| Proposed Doley Road Precinct Local Structure Plan Amendment No.3 – Schedule of Modifications |                   |  |  |

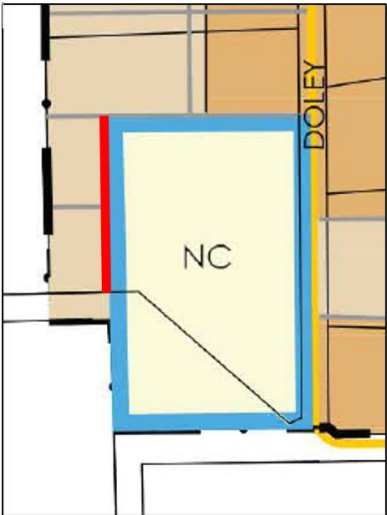
| 22.                     | LSP Map<br>& Various | <p>Modify the Local Structure Plan map to demonstrate a local road along the western boundary of the Neighbourhood Centre site, as identified in red below.</p>  | The amendment proposes the removal of a north-south local road and an east-west local road (the extension of the existing Bookleaf Street through to Doley Road). The amendment therefore proposes no public road along the entire western boundary of the centre site, suggesting that Linum Way and Bookleaf Street will terminate at the centre's edge, with residential lots directly abutting the neighbourhood centre site. It is not appropriate for residential lots to |

|     |                   |    | <p>directly abut a private commercial site with no separation via a public road or laneway, due to safety, road connectivity, and amenity reasons. This will 'cul-de-sac' Linum Way and Bookleaf Street, creating a poor road connectivity for use of residents, and emergency services vehicles. Officers recommend that the LSP map be modified to demonstrate a public local road along the western edge of the neighbourhood centre site.</p> |
